Safety Evaluation Report

NUREG-0308
Suppl. No. 1

related to operation of
Arkansas Nuclear One, Unit 2

Docket No. 50-368

Figure 2.1

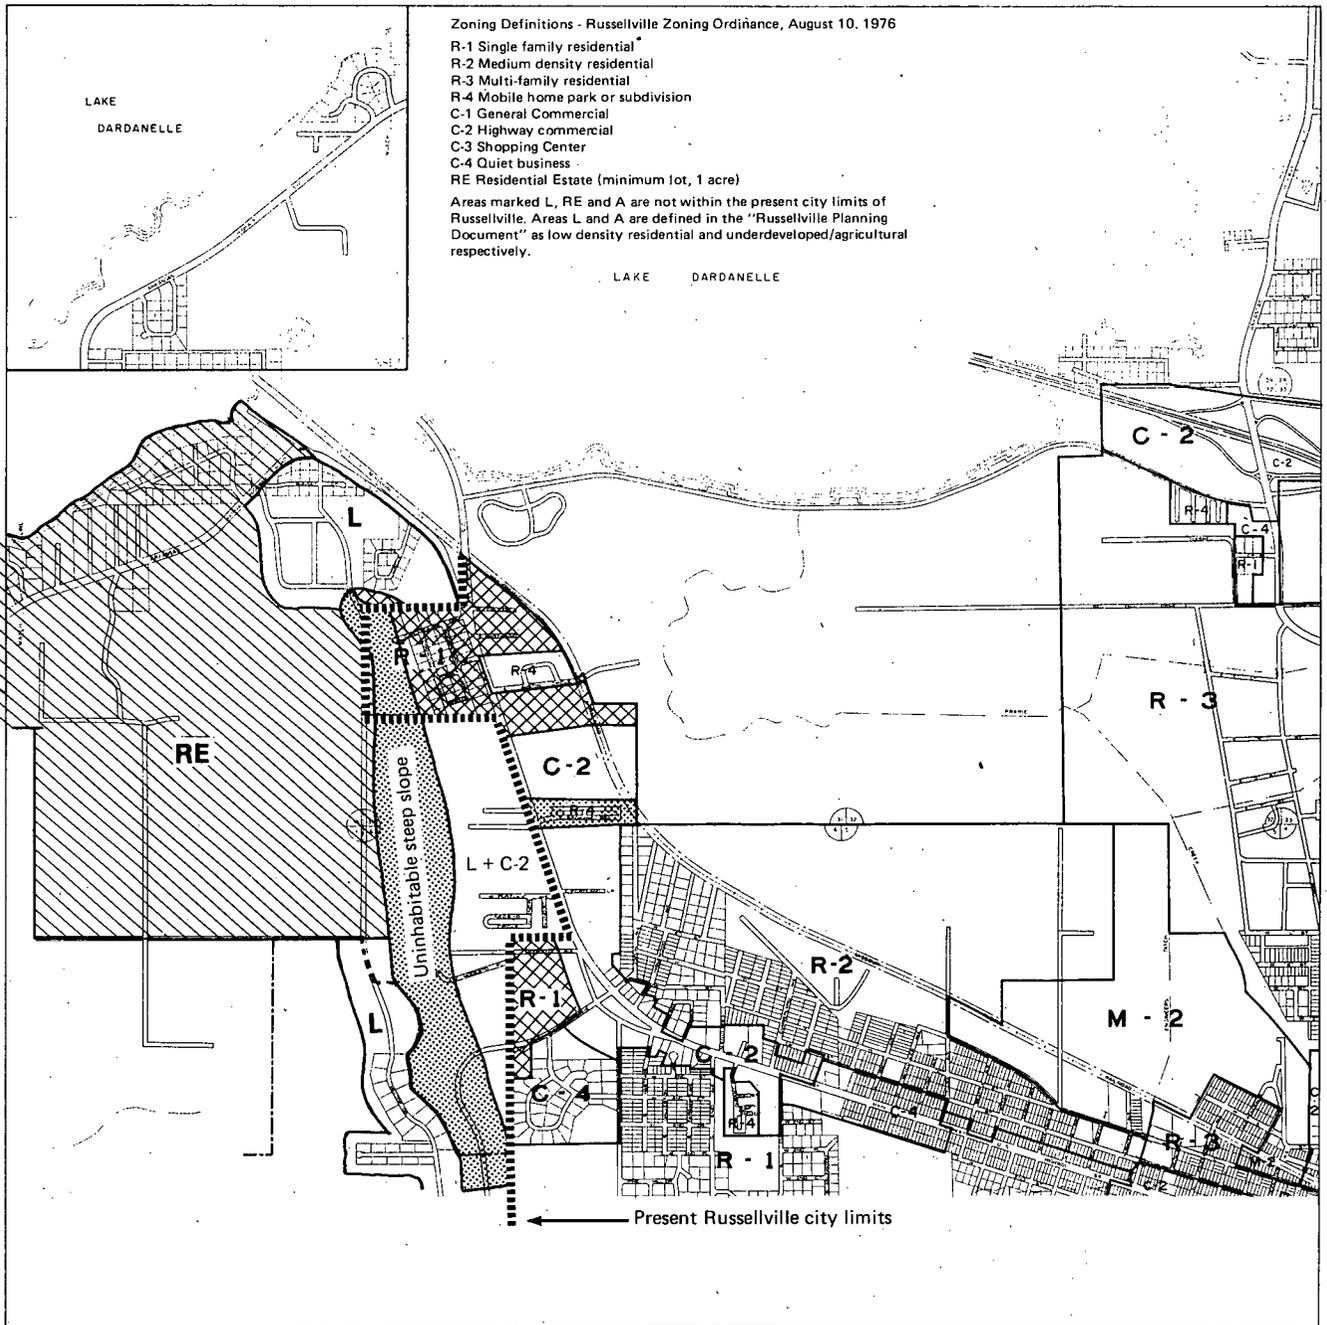
The applicant's submittal proposed establishment of the population center distance at Point B on Figure 2.1 which is about four miles from the plant site. As discussed above, establishment of the population center distance at that point would exclude from the population center areas in which the population density is equal to or greater than the average density of the population center itself. We can find no basis for concluding that such a proposal would meet the intent of 10 CFR Part 100 for determination of population center distance.

Based on the above considerations, we conclude that the boundary of the population center, Russellville, should be established at the nearest boundary of the R-1 zoning district at the western edge of the city since it marks a clear delineation between the population density of the city and the surrounding areas. This point is identified as Point A on Figure 2.1, and is about 5600 meters (3.5 miles) from the plant site. The corresponding low population zone radius is 4200 meters (2.6 miles).

The applicant has recently stated in a meeting held with the staff on January 25 and 26, 1977 that they planned not to pursue justification of a low population zone radius of greater than this 2.6 mile distance and indicated that they would amend the ANO-2 application to reflect the 2.6 mile low population zone radius.
